FACILITIES PROGRAM UPDATE
UTAH STATE DEVELOPMENTAL CENTER
ADMISSIONS AND SAFE HOUSING
895 NORTH 900 EAST, AMERICAN FORK, UTAH

DFCM PROJECT # 14068410

PROGRAM
SUPPLEMENT
#1

NOVEMBER 4, 2014

- DOOR SWINGS IN RESIDENT ACCESS AREAS
See Attachment #1

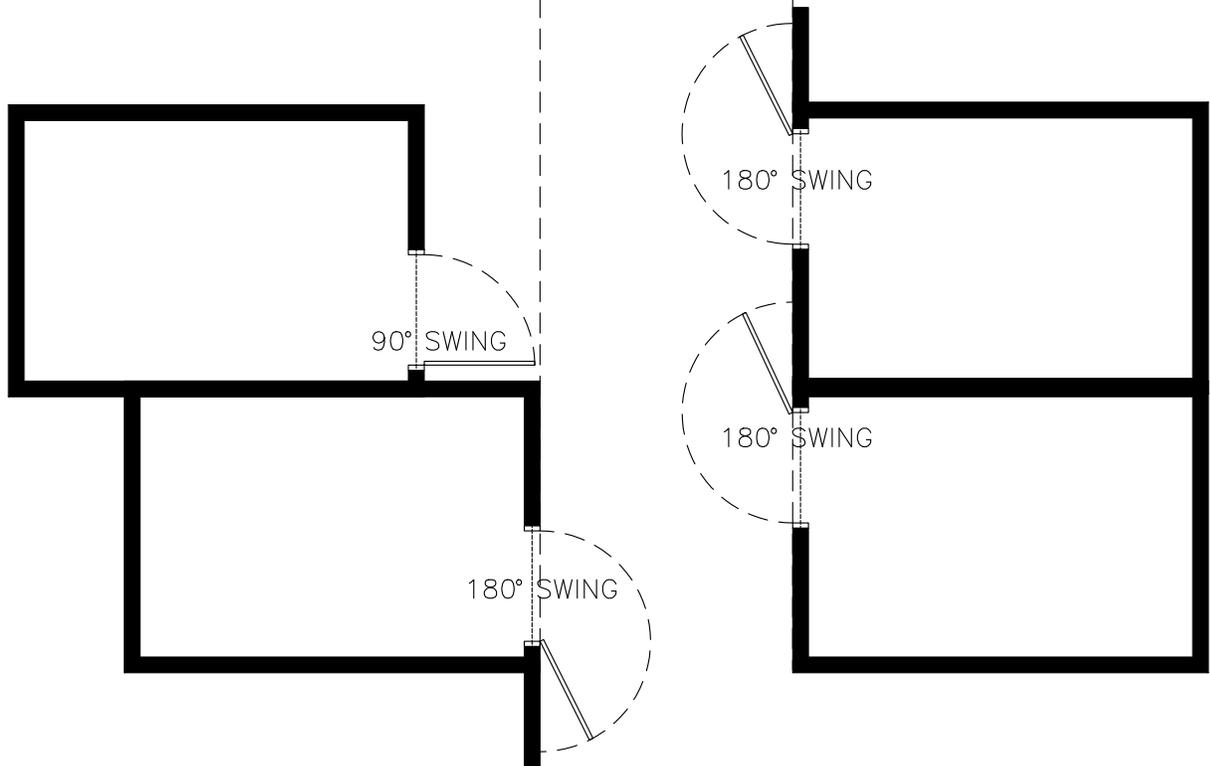
NOT ACCEPTABLE DOOR SWINGS
NOTE: BEDROOM DOORS SHOULD NOT BE DIRECTLY ACROSS FROM EACH OTHER

ACCEPTABLE DOOR SWINGS
